Addendum No. 3

January 25, 2024

Subject: 2024 MAINTENANCE REPAIRS
City of Dunwoody Parks – Shallowford Annex Building
4470 N. Shallowford Rd, Atlanta, GA 30338

2 ELEVATION - EAST WALL ELEVATION REPAIRS
SCALE: NOT TO SCALE

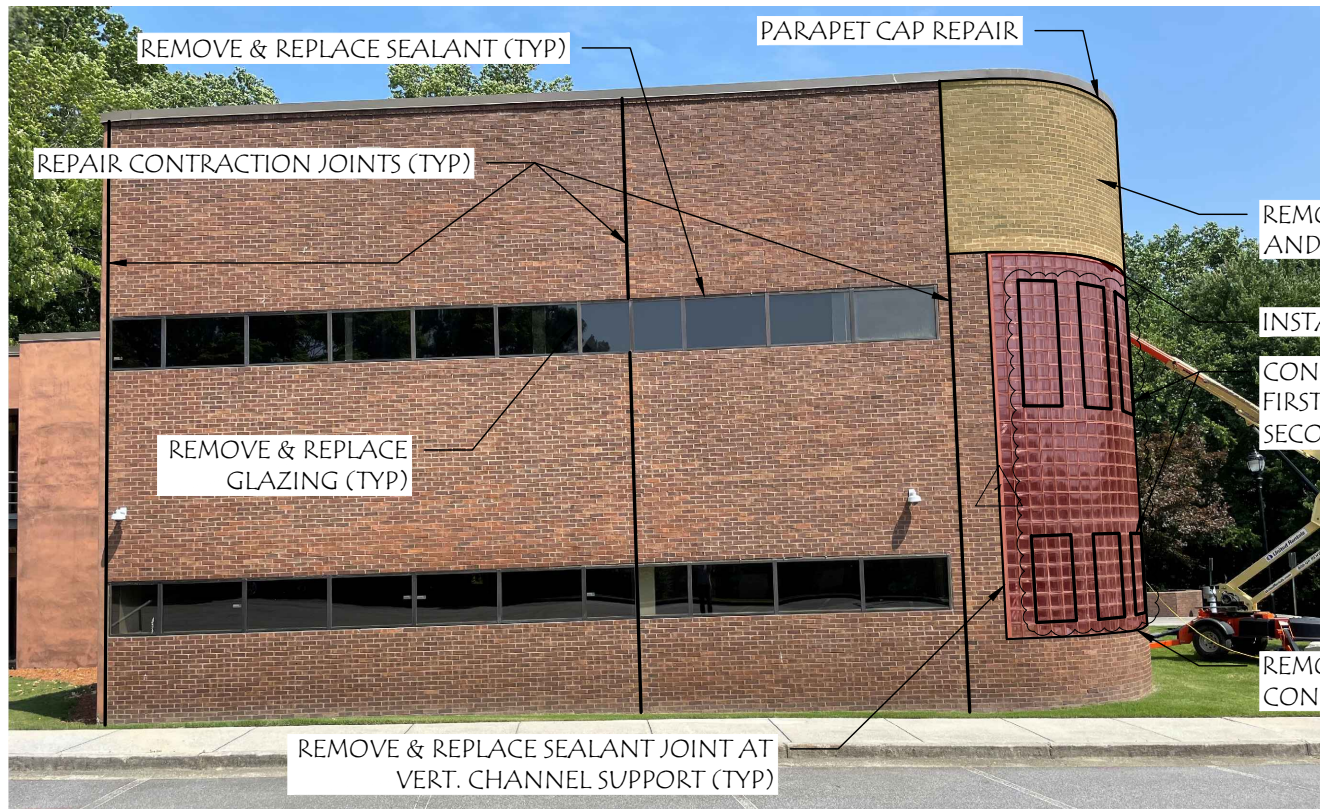
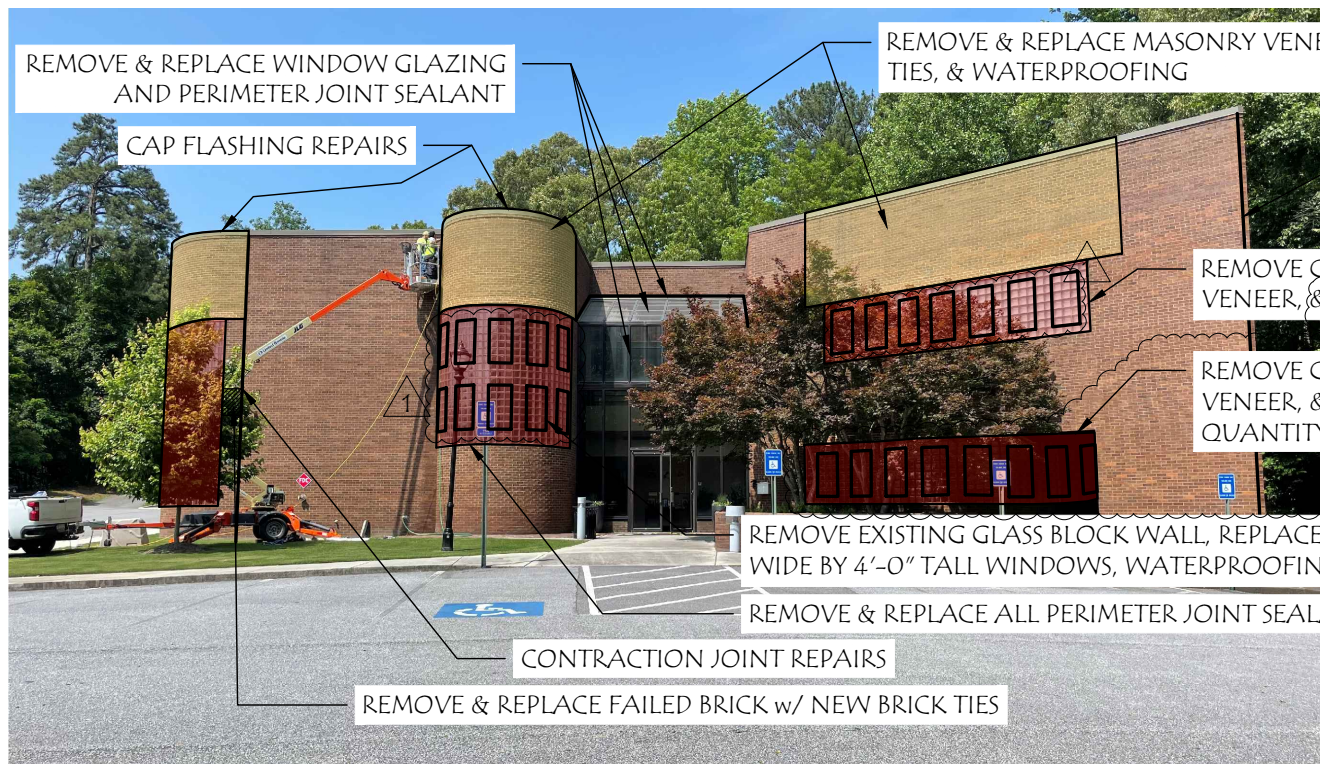
1.1.2 Sheet R9

- 1.1.2.a Added the lower-level room on the east elevation near the north east corner. This is in detail 2/R9 and 1/R10.
- 1.1.2.b The approximate location of windows is show on elevation figures.
- 1.1.2.c Window sizes and estimated quantities were added. The contractor shall measure dimensions and confirm the quantities fit.

- 2.8 **Is the level 1 assembly space in the northeast corner included in the block removal and replacement?**
- 2.8.1 Yes. Drawings were modified to reflect this removal and replacement. This is shown in detail 2/R9 and 1/R10.

SHEET No.
R9

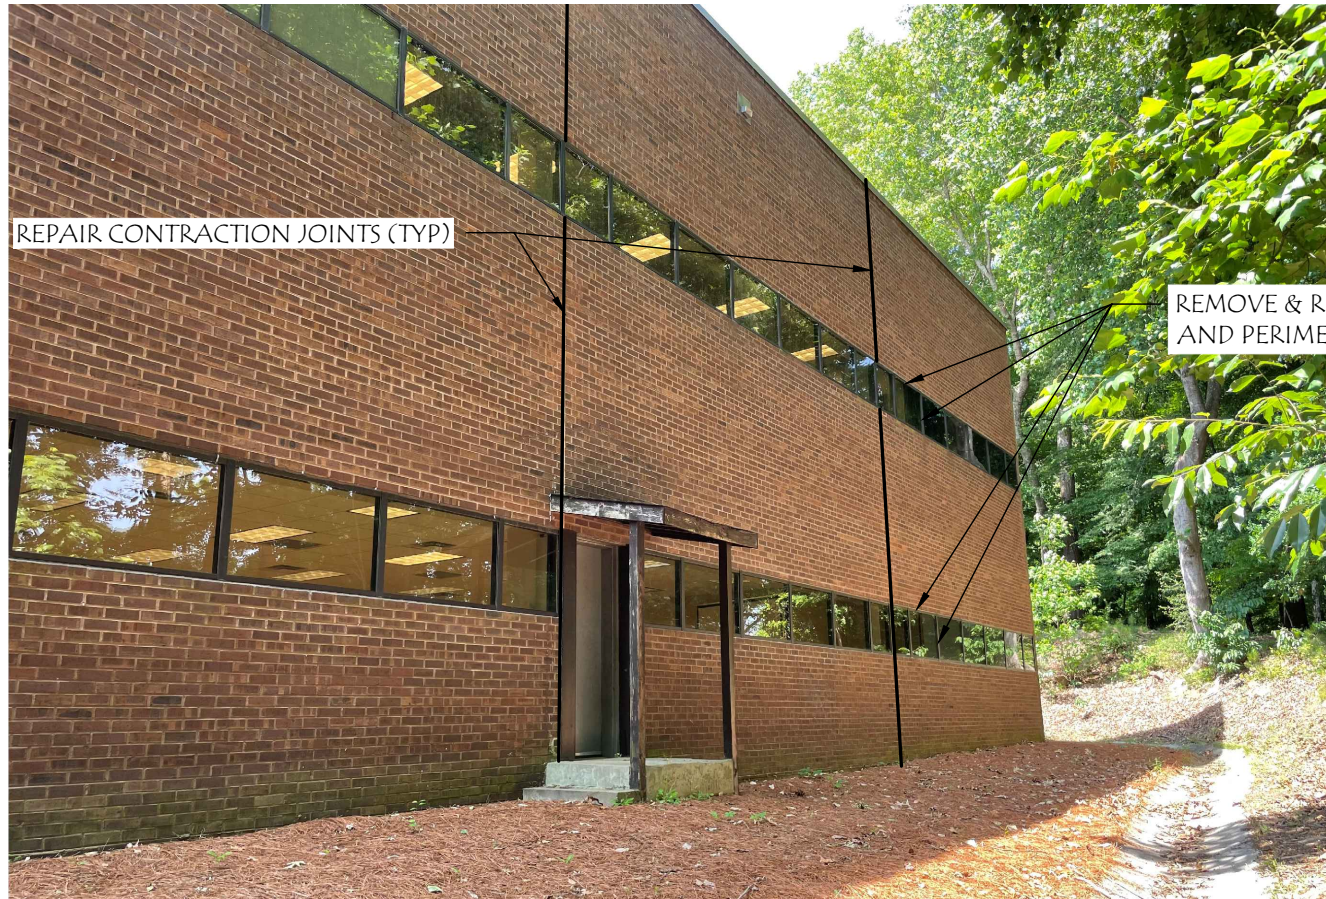
1.1.3 Sheet R10

- 1.1.3.a Added the lower-level room on the east elevation near the north east corner. This is in detail 1/R10 and 2/R9.
- 1.1.3.b The approximate location of windows is show on elevation figures.
- 1.1.3.c Window sizes and estimated quantities were added. The contractor shall measure dimensions and confirm the quantities fit.

SHEET No.
R11

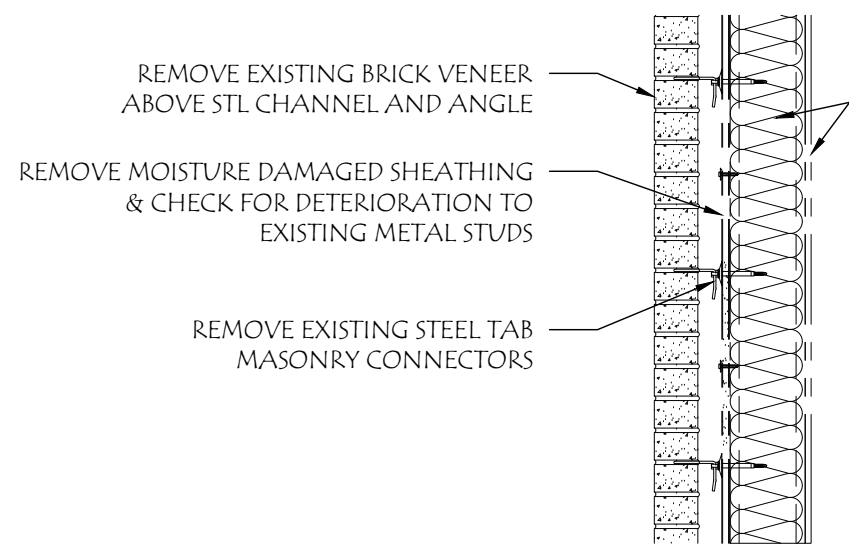
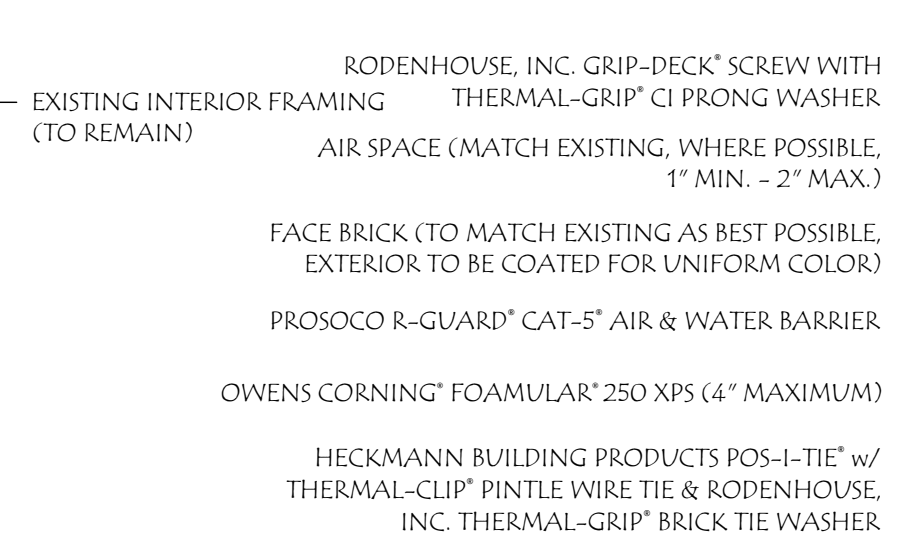
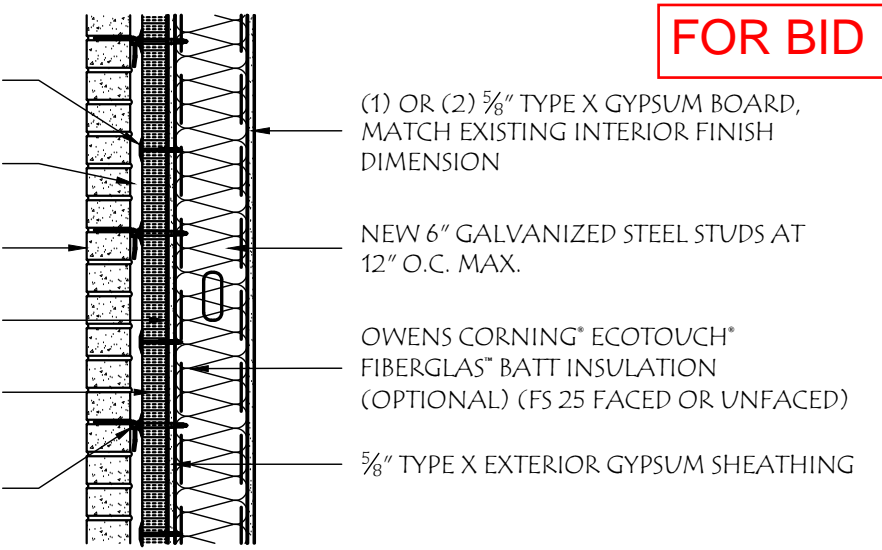
1.1.4 Sheet R11

- 1.1.4.a Updated detail callouts.
- 1.1.4.b Added detail callout for wall section demo and wall section repair above the glass block tile.
- 1.1.4.c Provided a section callout for the window detail in 3/R11.
- 1.1.4.d Modified the wall section names for better clarity.

SHEET No.
R12

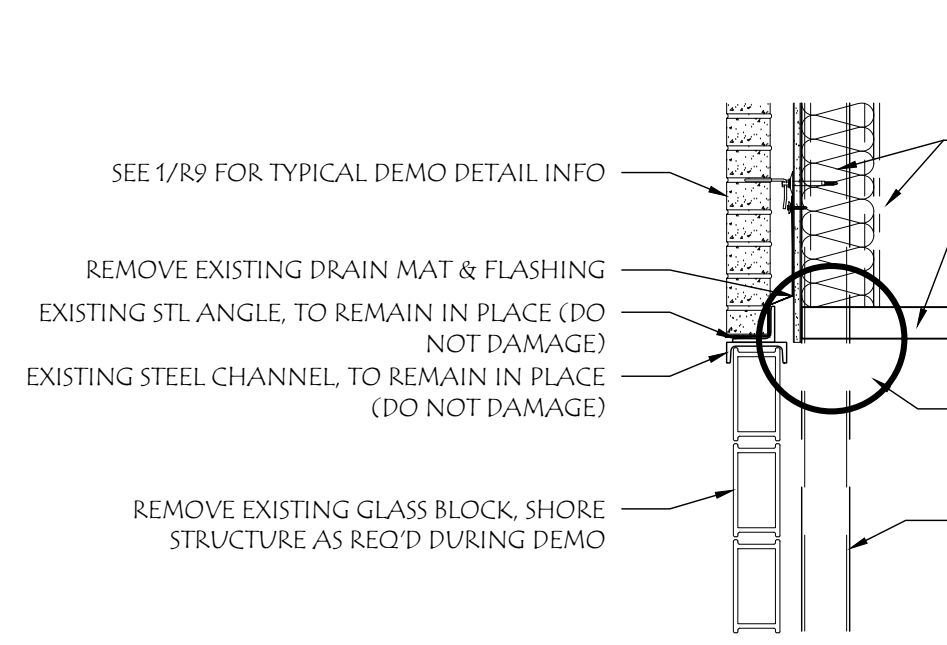
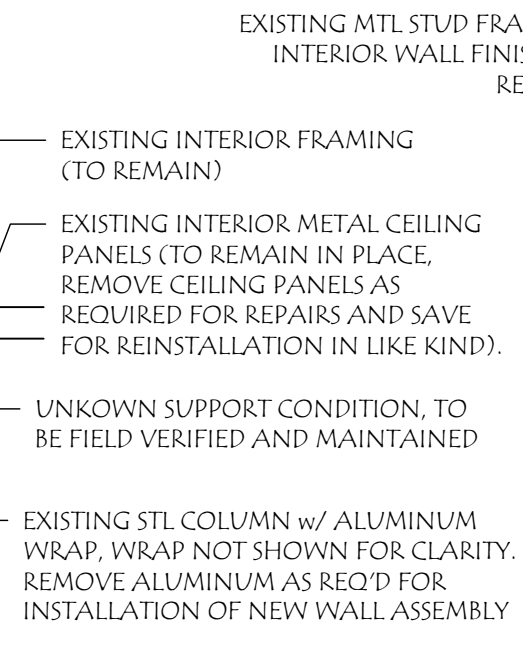
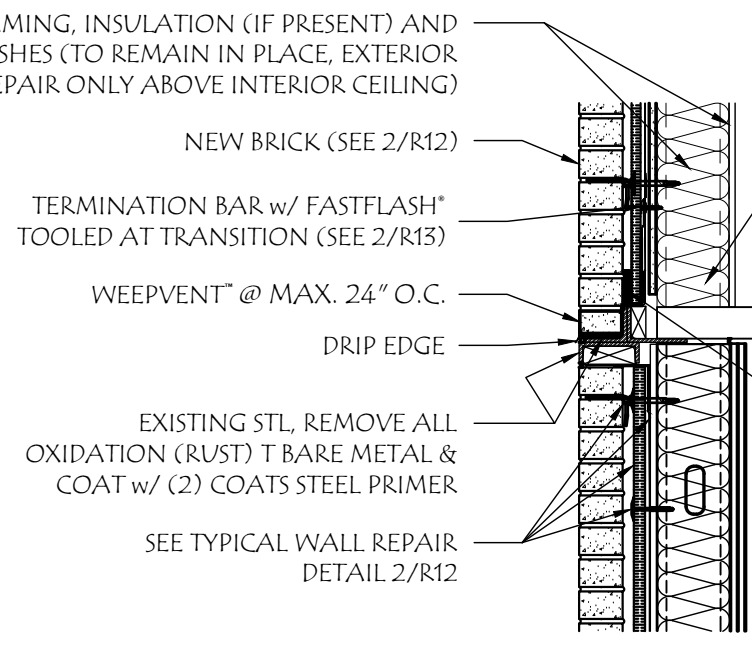
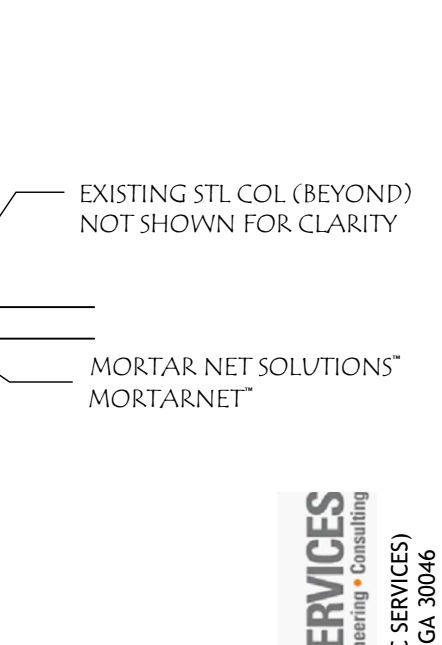
1.1.5 Sheet R12

- 1.1.5.a Modified the wall section name for better clarity.

4 TYPICAL - PARTIAL PLAN AT NEW STUD/VENEER WALL
SCALE: NOT TO SCALE

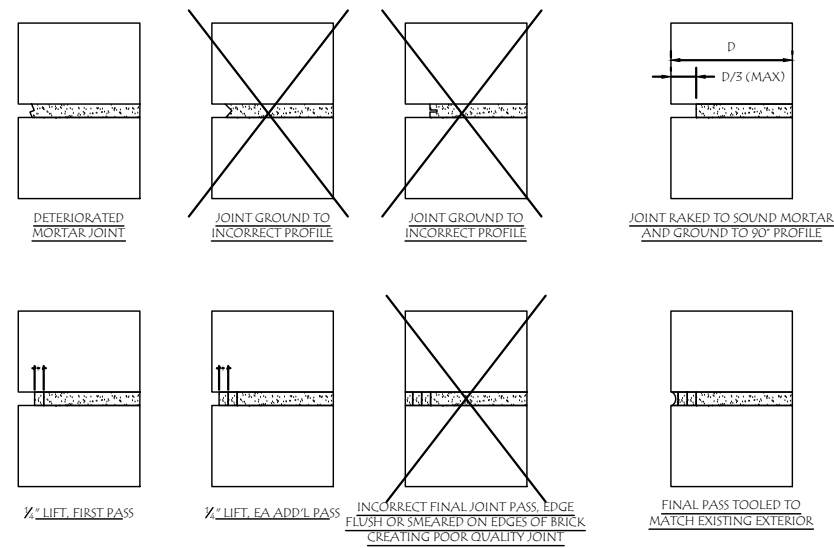
1.1.6 Sheet R15

- 1.1.6.a Added detail 4/R15 to show schematic window in partial plan view within the radiused wall section.
